PLANNING & ZONING AGENDA ITEM #6

SUBJECT: Approval of a Site Plan for Alice Place Retirement Village [255 SE Brick Drive]

COMMENT RESPONSE LETTER

RE: Alice Place Retirement Village – Site Plan

ALICE PLACE RETIREMENT VILLAGE
DETAILS
WAUKEE, IOWA

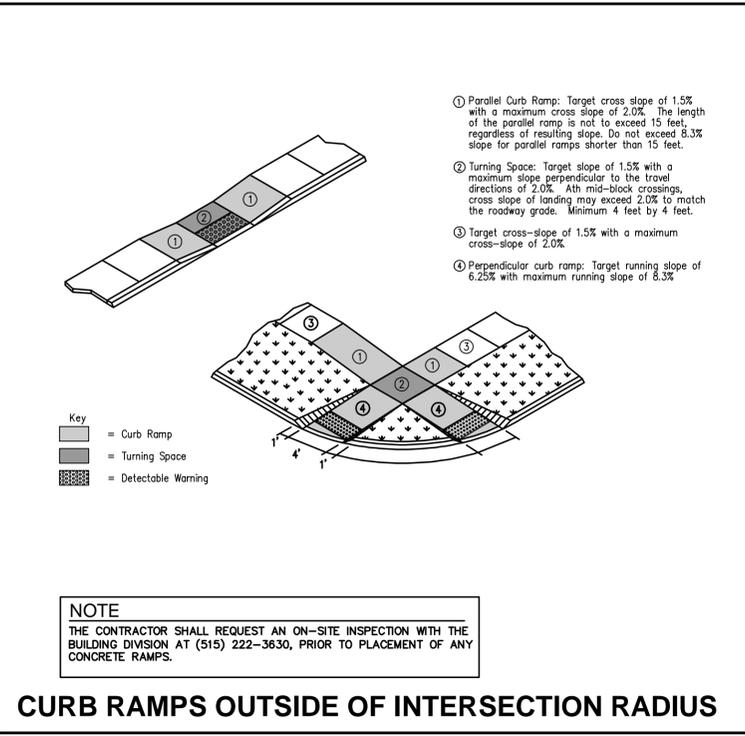
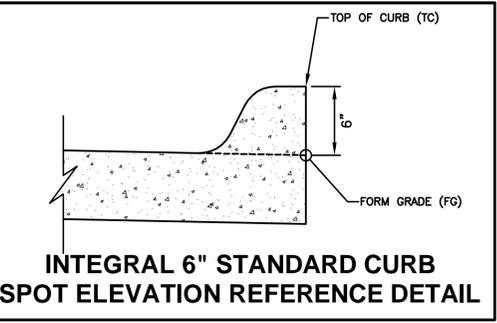
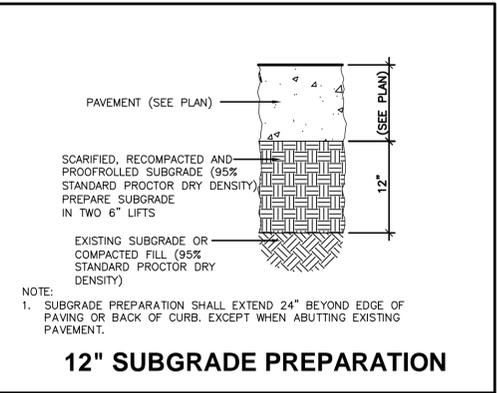
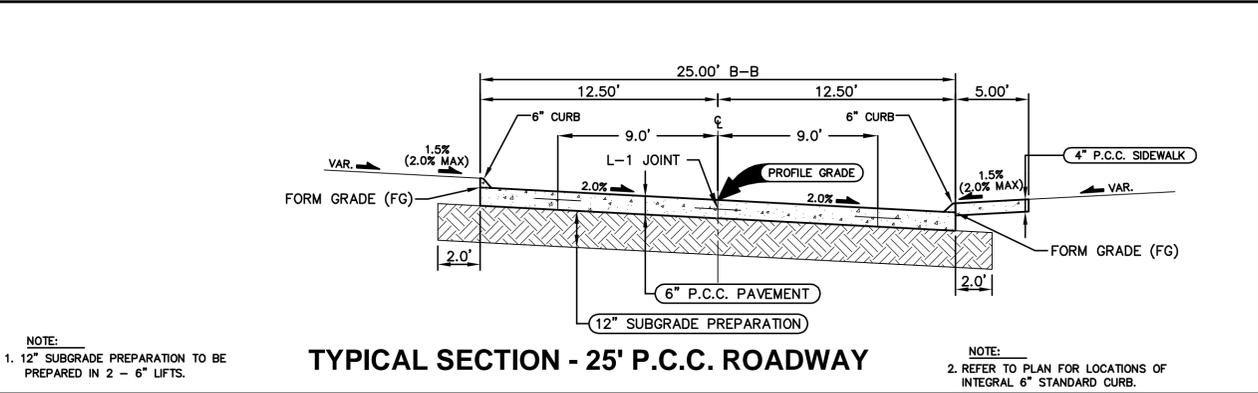
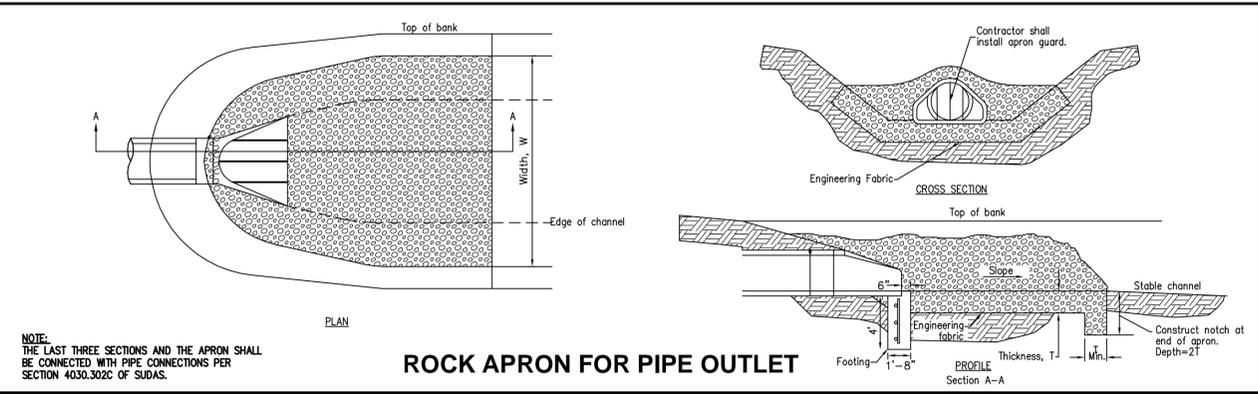
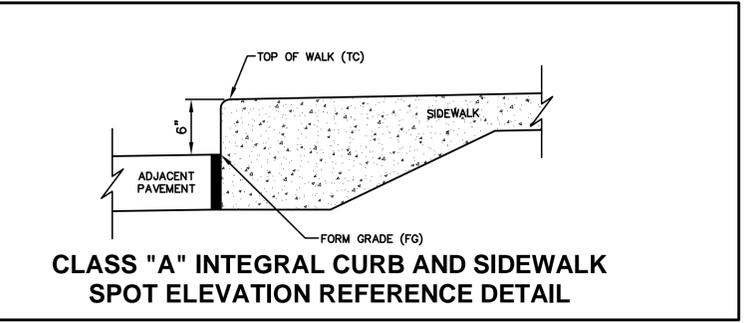
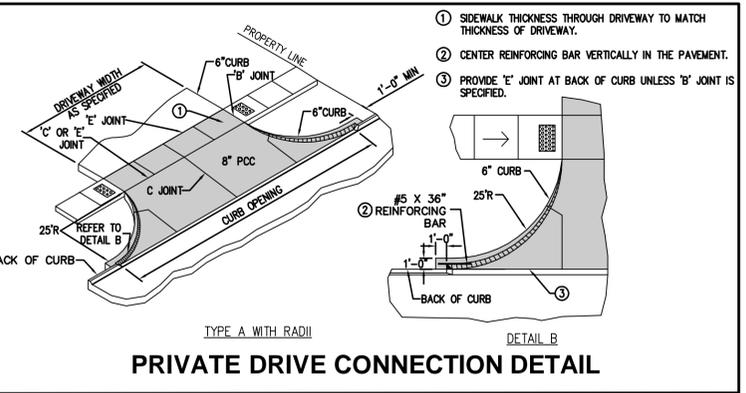
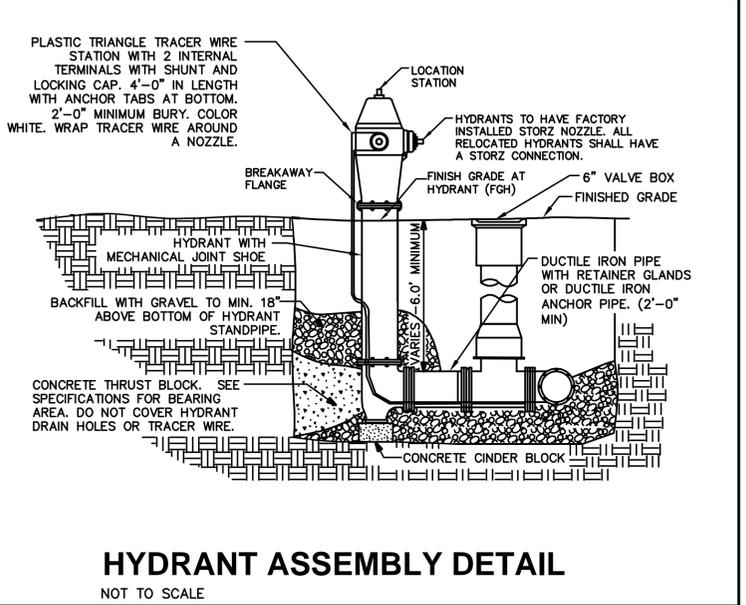
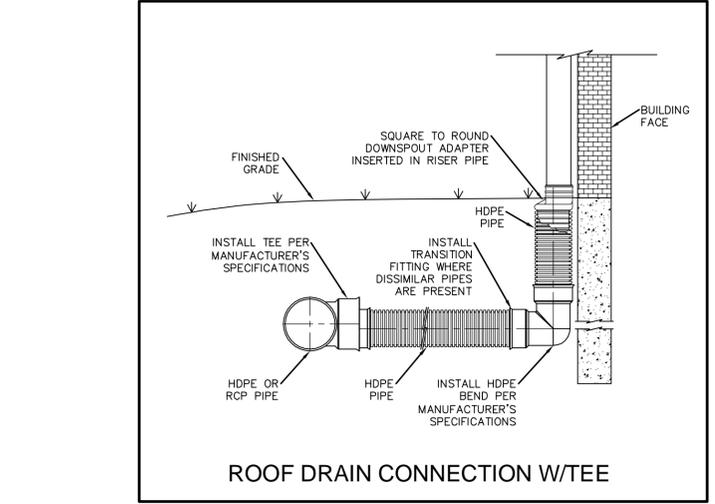
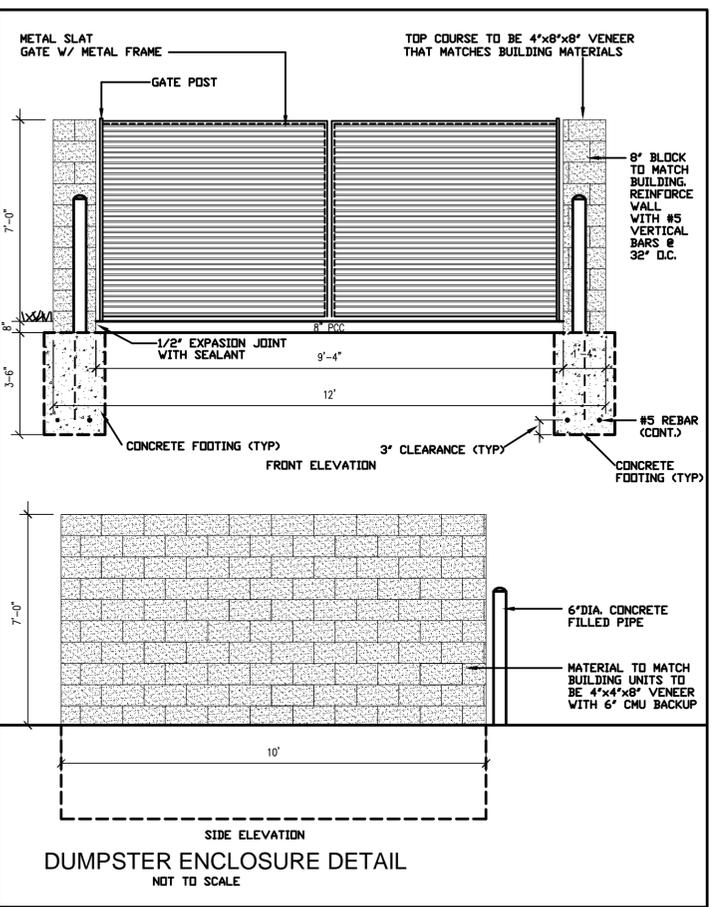
9. **The Rock Apron For Pipe Outlet detail should be revised to include the required installation of an apron guard.**

9. The Rock Apron For Pipe Outlet detail should be revised to include the required installation of an apron guard.
 - a. **The detail has been modified to include the apron guard.**

ALICE PLACE RETIREMENT VILLAGE
DIMENSION PLAN

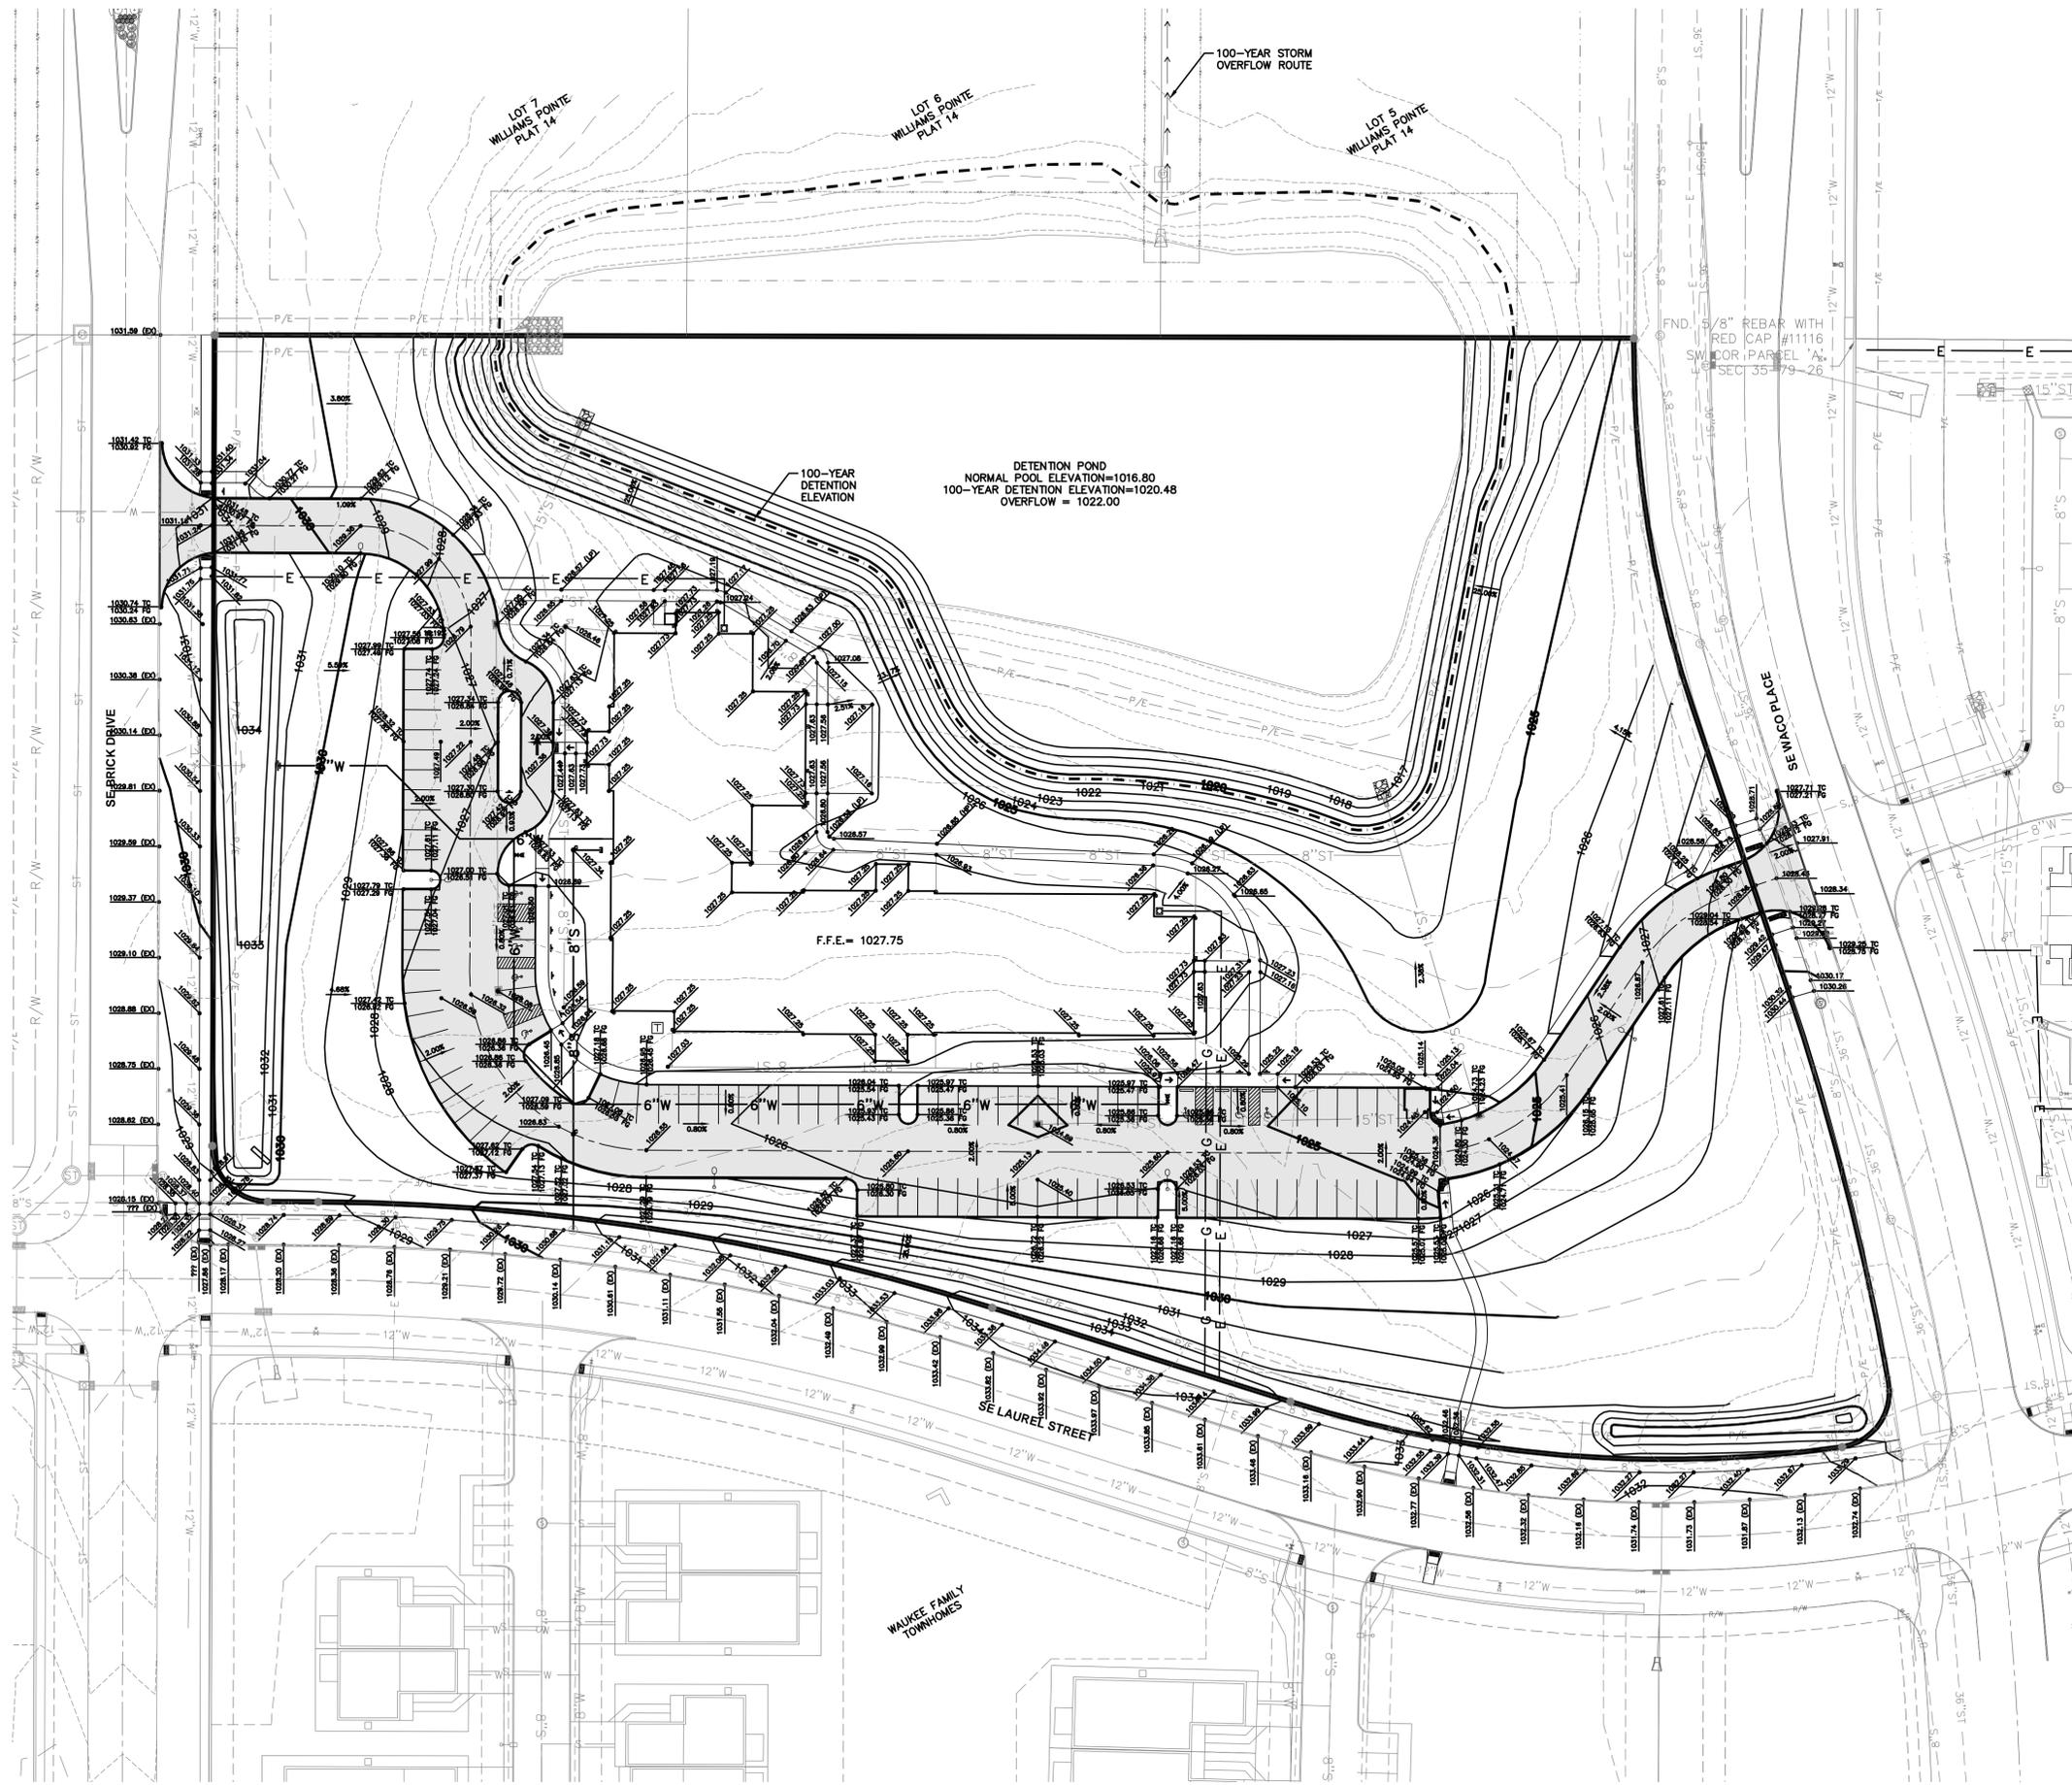
20. Site striping and traffic circulation controls should be indicated on the site plan for clarity as there is an assumed one-way past the main entry to the building. **The one-way drop off lane appears to be set up as a clockwise access and staff questions if the drive should be counter clockwise as would be more typical. Please address.**

22. Staff questions how garbage is intended to be stored and picked up for the property. An enclosure should be identified on the site plan if applicable and a detail of the enclosure included with the elevation drawings. Please address. **Verify that there is a minimum of 2 feet from the edge of the proposed trash enclosure wall and the edge of the nearest parking stall per the Parking and Loading Areas Ordinance. Additionally, staff would request that the dumpster detail be moved to Sheet 2 and a reference to the detail location within the plan set be called out on the dimension plan.**

23. All public sidewalks should be revised to a minimum 5 feet in width to comply with current ADA requirements. **Verify that all details provided as a part of the plan set are reflective of the 5 foot width.**

- a. **The arrow has been modified to flow the other way.**
22. ~~Staff questions how garbage is intended to be stored and picked up for the property. An enclosure should be identified on the site plan if applicable and a detail of the enclosure included with the elevation drawings. Please address.~~ Verify that there is a minimum of 2 feet from the edge of the proposed trash enclosure wall and the edge of the nearest parking stall per the Parking and Loading Areas Ordinance. Additionally, staff would request that the dumpster detail be moved to Sheet 2 and a reference to the detail location within the plan set be called out on the dimension plan.

- a. **The enclosure has been modified to provide 2 feet of clearance between the parking space.**
23. ~~All public sidewalks should be revised to a minimum 5 feet in width to comply with current ADA requirements.~~ Verify that all details provided as a part of the plan set are reflective of the 5 foot width.

- a. **The typical cross section has been modified to 5 feet.**
